Piper Aircraft Corporation

Subject: Modification to the Fuselage Bulkhead

Models Affected: PA-31 Navajo
PA-31-350 Navajo Chieftain

View looking forward.
Bulkhead Sta. 100.00

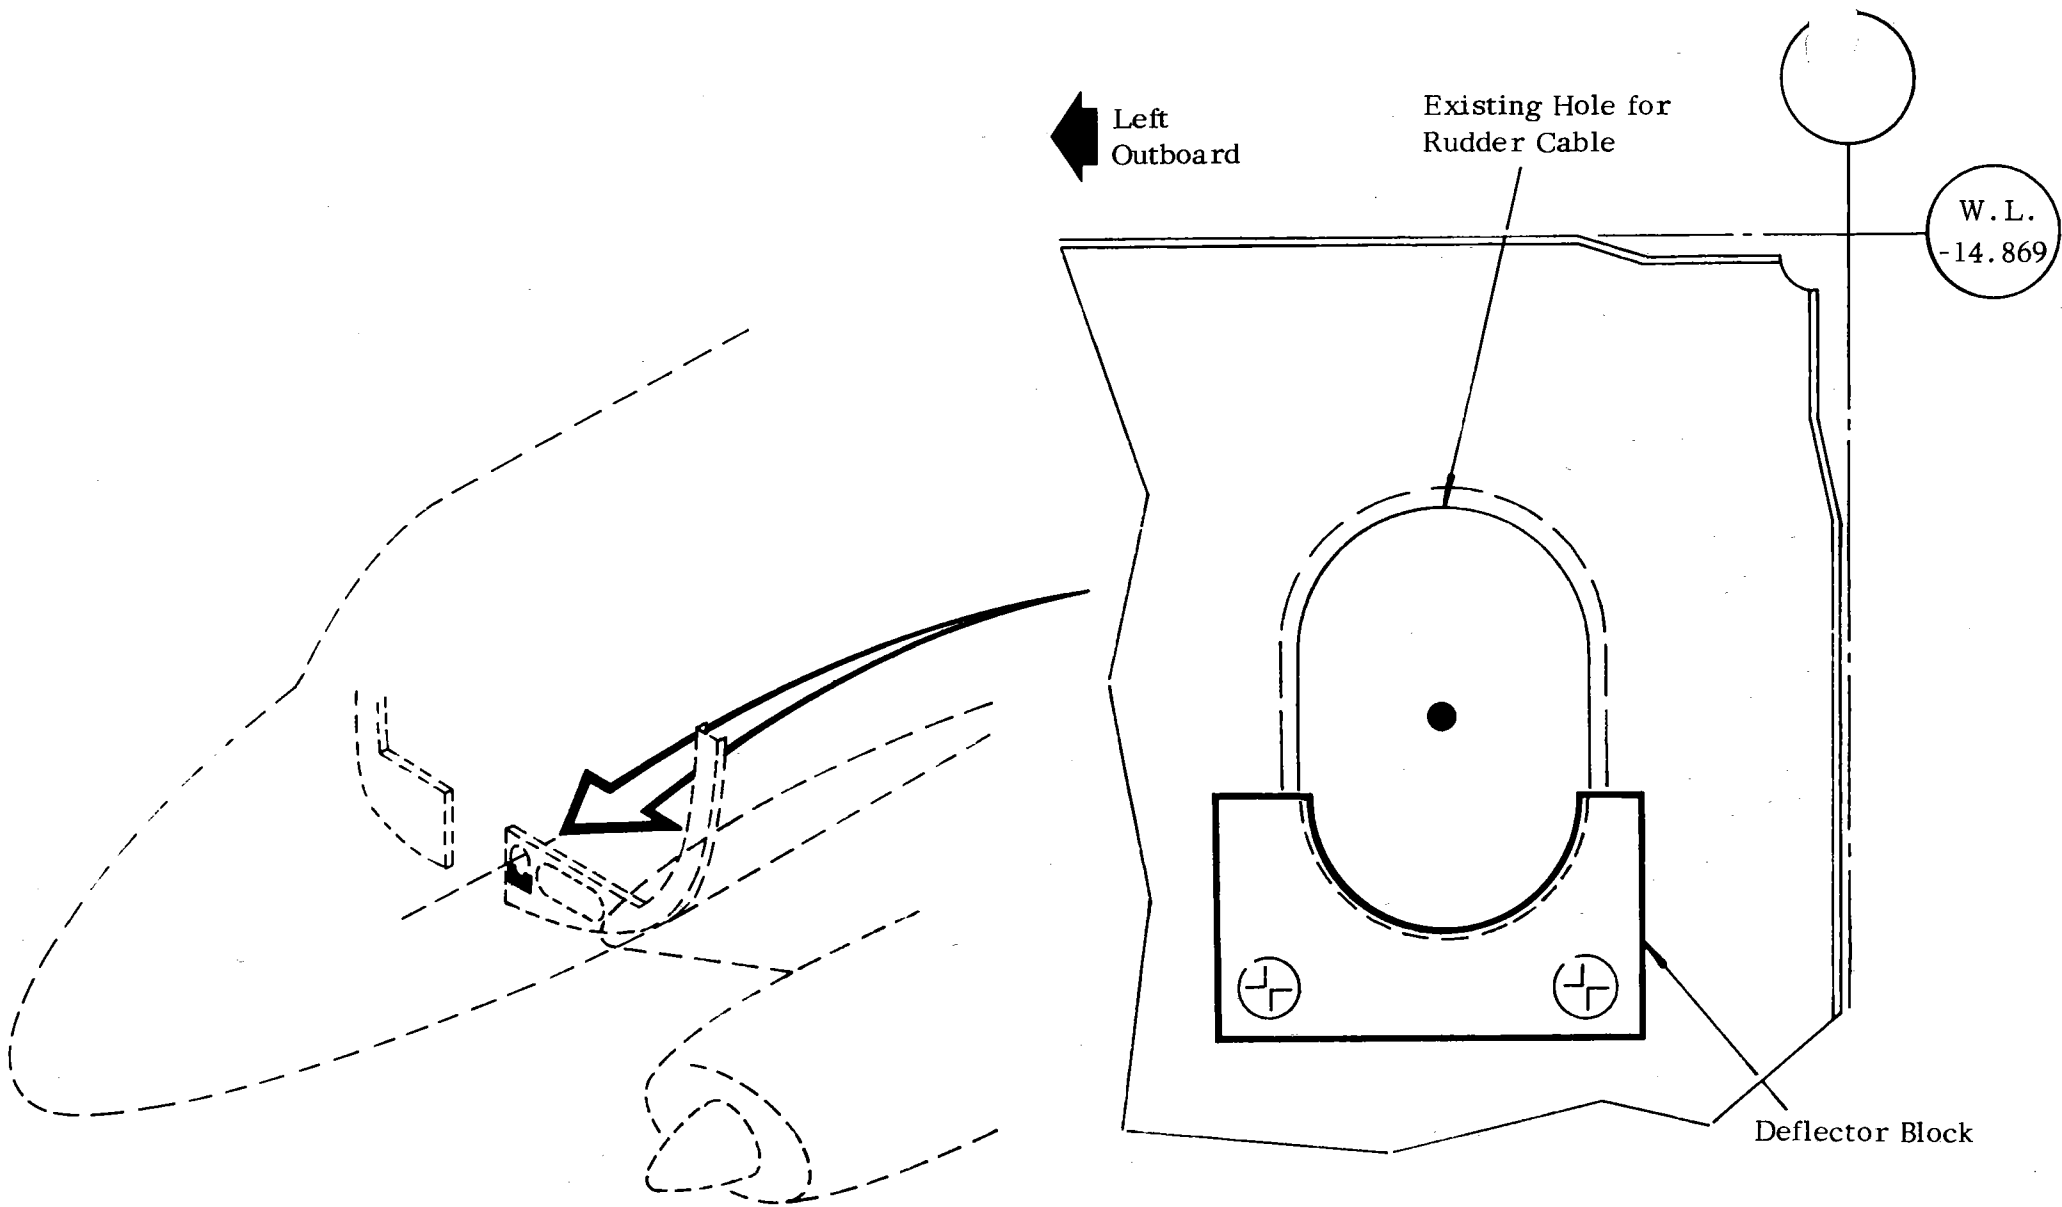
Purpose: To provide materials and instructions necessary to install a phenolic guard block at fuselage bulkhead station 100.

Installation of the phenolic guard block device contained in Kit No. 760 295 will preclude the possibility of the rudder cable contacting the bulkhead cutout at fuselage bulkhead station 100. (See sketch on reverse side of this letter for more descriptive information.)

Instructions: Contained in Kit No. 760 295; Fuselage Bulkhead Modification.

Material Required: One (1) each Fuselage Bulkhead Modification Kit, Piper Part No. 760 295.
